Service Information

Category T	Repair Guidance	Ref. No. R111/13A	Page 1 of 4
Coverage <input type="checkbox"/> Distributor only <input checked="" type="checkbox"/> Please inform your dealers		Date Issued December 24, 2013	
Please convey this information to your <input checked="" type="checkbox"/> Warranty Dept. <input checked="" type="checkbox"/> Parts Dept. <input checked="" type="checkbox"/> Training Dept. <input checked="" type="checkbox"/> Field Rep.		Date Revised February 6, 2014	
Mazda3(BM) with center display & CD player		Applicable Countries or Specifications Worldwide(Except for North America)

REVISED

Subject: CD Player Display Concerns

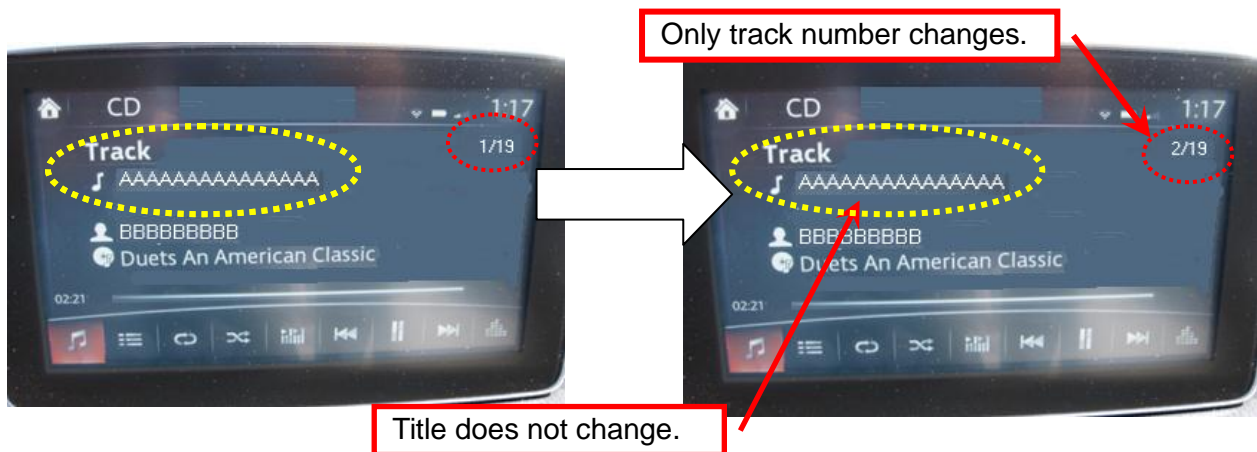
Some vehicles may experience the two symptoms mentioned below when playing CD.

Symptom 1: Title indication (song title) on the CD display does not change when it turns into the next tune (song). However, only the music order indication (track number) changes.

Symptom 2: Track list does not open after inserting the CD, but the "Disc loading" will appear on the display.

Improper software of CD player.

The software of CD player has been changed.

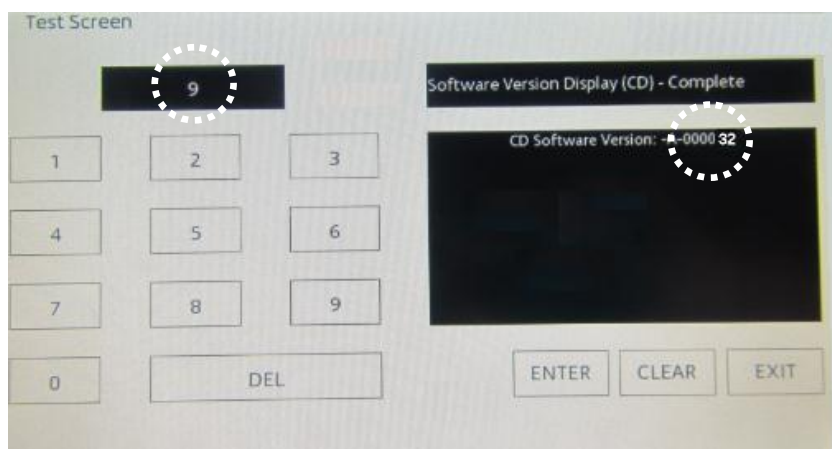
1. Press the three buttons (Music (A) + Favorites (B) + Volume Mute(C)) on the commander switch at the same time for 2-5 seconds and the Diagnostic Test Screen will appear.

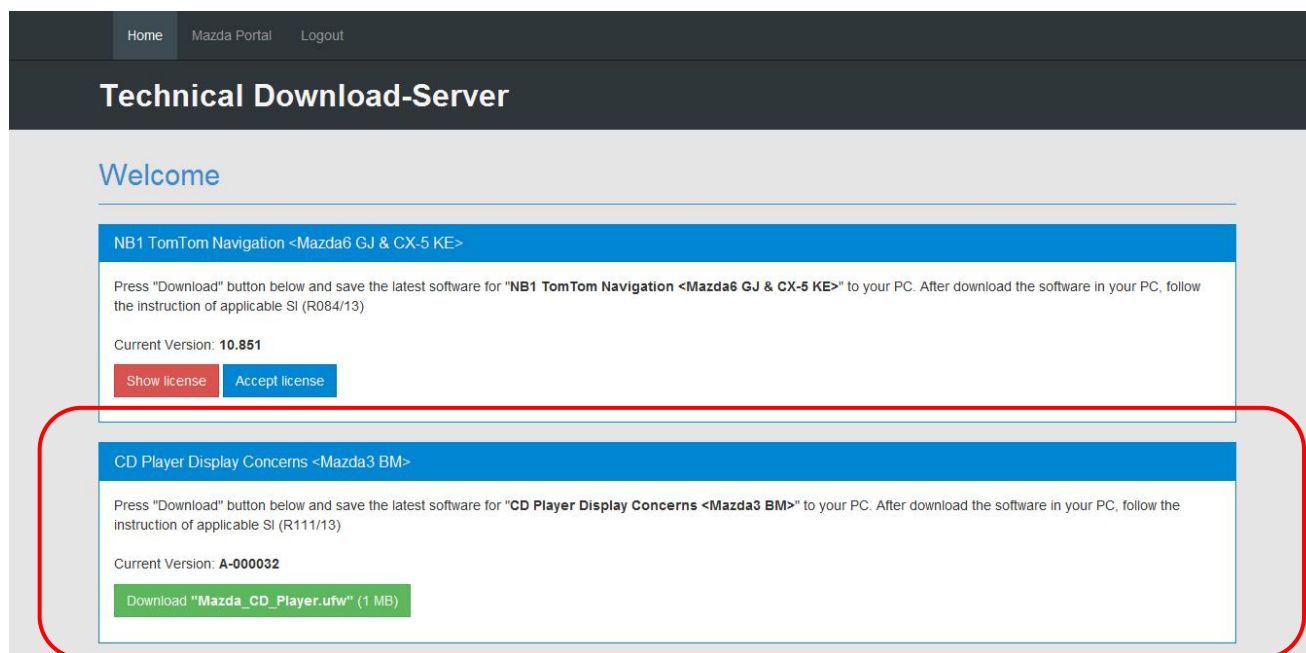
2. Use the touchscreen or the commander switch to input '9' and then select "ENTER" on the Test screen.

3. Make sure the last two digits of the CD player software version, If two digits are "32" , **this Service Information is not applicable.**
If software version is below "32", perform CD player software update referring to "Repair Procedure".
